State of New Mexico
Energy, Minerals and Natural Resources

Form C-103
October 13, 2009

WELL API NO. 30-015-24653
5. Indicate Type of Lease STATE ☒ FEE ☐
6. State Oil & Gas Lease No. NM01119
7. Lease Name or Unit Agreement Name Avalon (Delaware) Unit
8. Well Number 210
9. OGRID Number 007673
10. Pool name or Wildcat Avalon Delaware 3715

ADU 210 Plugging Procedure:

ADU 210 Proposed Wellbore Schematic

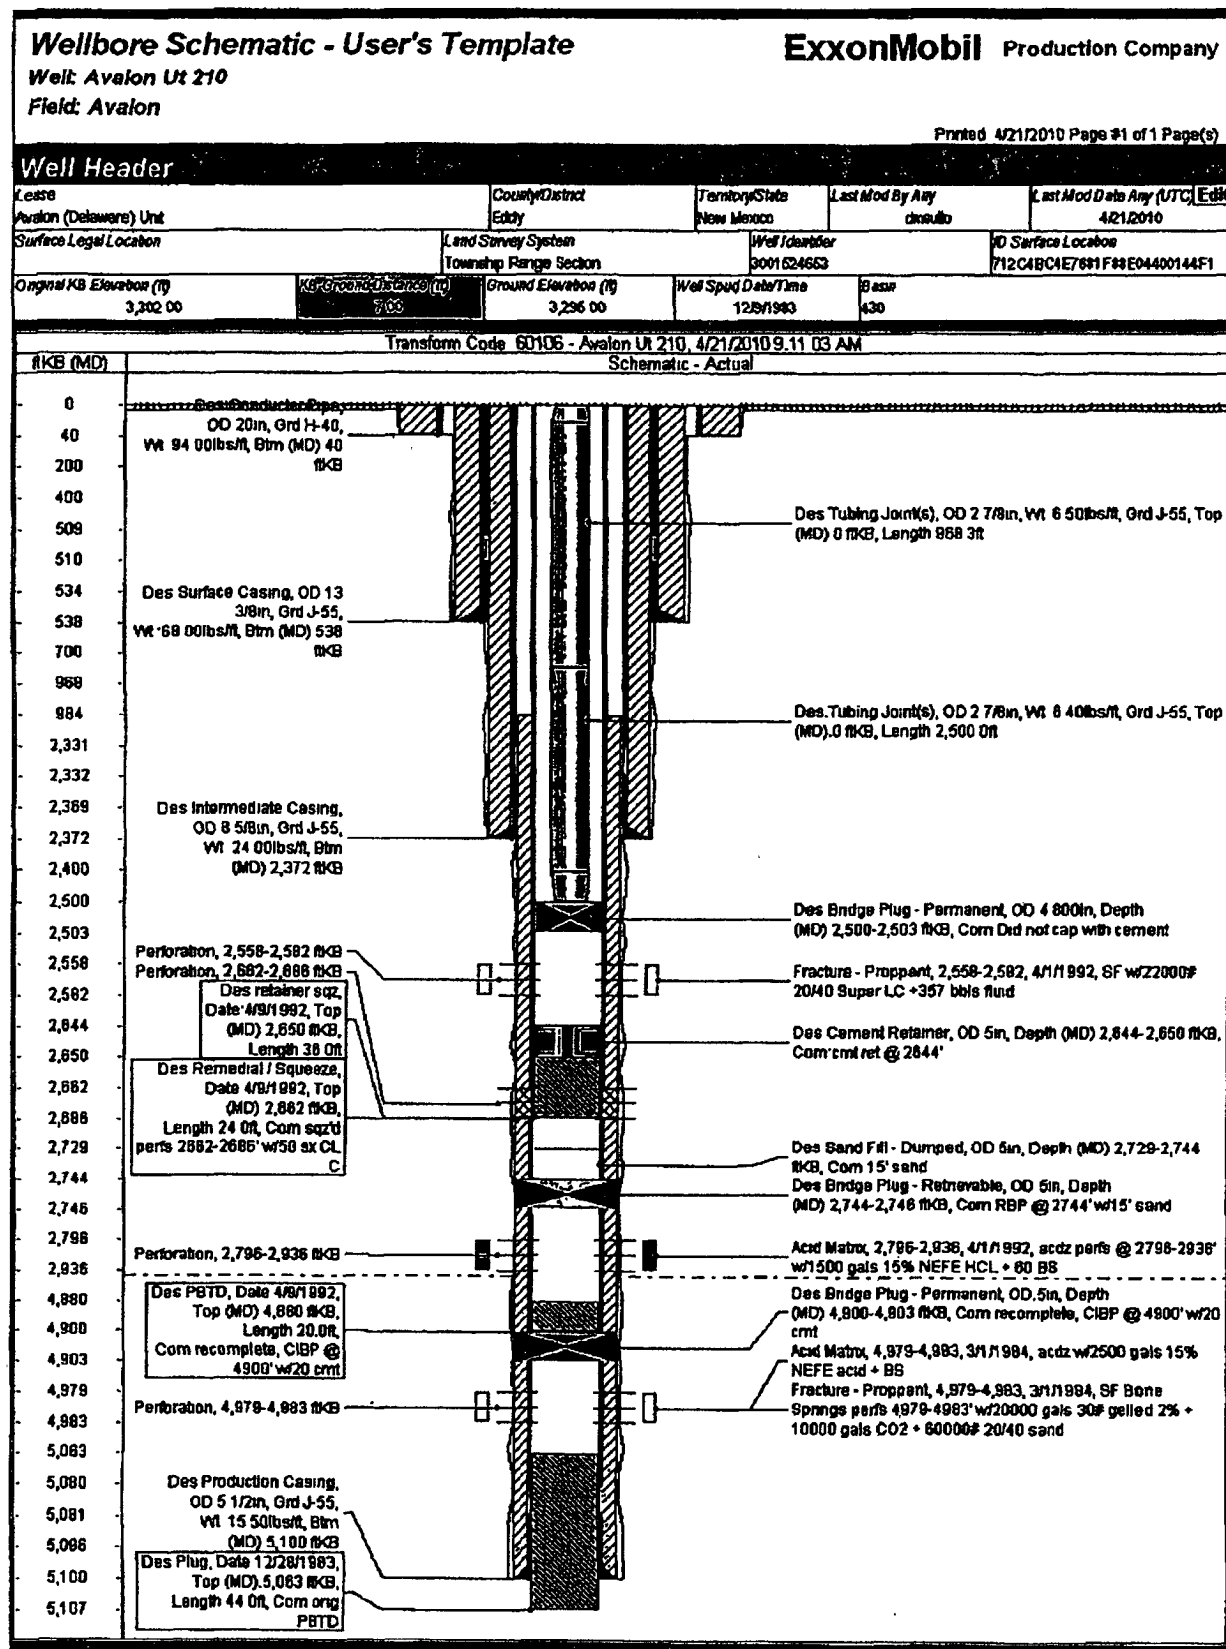
⑦ Spot 25 sks of C cement @ 2,500'-~~2,400'~~ Tag plug.

2322'

17. * 8 5/8" csg shoe @ 2372' 100' cement plug 2422'-2322' woc tag
2500'-2322'

Approval Granted providing work
is complete by 9/6/2010
